ADMINISTRATIVE AMENDMENT (PD) ADD2023-00016

ADMINISTRATIVE AMENDMENT
LEE COUNTY, FLORIDA

BAYSHORE 57
ADMINISTRATIVE AMENDMENT
MIXED USE PLANNED DEVELOPMENT
Request Statement

DEVIATION 8 LOT SIZE DETAIL

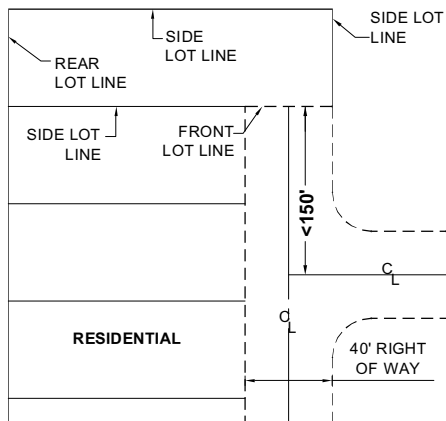
8. **Deviation 8** seeks relief from LDC Section 10-703, which establishes lot size measurements, to allow lot size to be measured as indicated on the Master Concept Plan Alternate B “Deviation 8 Lot Size Detail” is hereby APPROVED.

8. Deviation from LDC Section 10-703 to allow lot size to be measured as indicated on the Master Concept Plan.

line #3 is 90 degrees to side lot line two. Lot line three is the length of lot line one plus the width of the right of way. Using the criteria for measuring lot depth as illustrated in LDC Section 10-703, side lot line #2 would cause this end lot to fail to meet minimum lot depth. To assist in future compliance review and to clarify this request additional notes have been added to Deviation 8 detail on the plans.

PARCEL ROAD TYPICAL CROSS SECTION

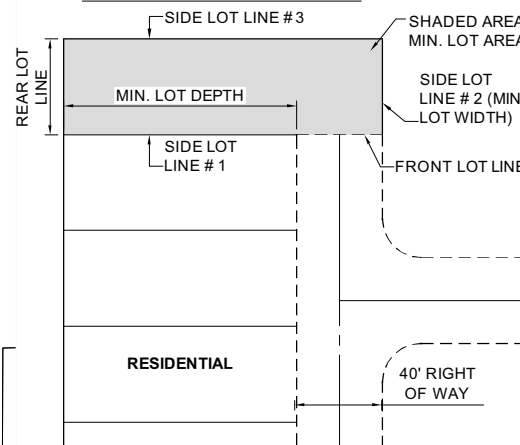
11. **Deviation 11** seeks relief from LDC Section 10-296(e)(2)h.5.ii, which requires streets to provide a sidewalk on one side of the road for residential subdivisions with a 5-foot planting strip, to allow a split 5-foot wide planting strip with 4 feet between the sidewalk and back of curb. This Deviation is hereby APPROVED.

11. **Deviation from LDC Section 10-296(e)(2)(h)(5)(ii) which requires residential streets to provide a streetside 5-foot wide planting strip to allow a split 5-foot wide planting strip on MCP Alternate B.**

Justification: This deviation request applies to parcel roads only. The applicant requests to provide a 4-foot wide planting strip between the sidewalk and back of curb, only one foot less from the LDC requirement. However, the applicant also proposes to provide a 1-foot planting strip on the other side of the sidewalk for a total of 5 feet, please see the Parcel Road Typical Cross Section on MCP Alternate B for details. The proposed planting
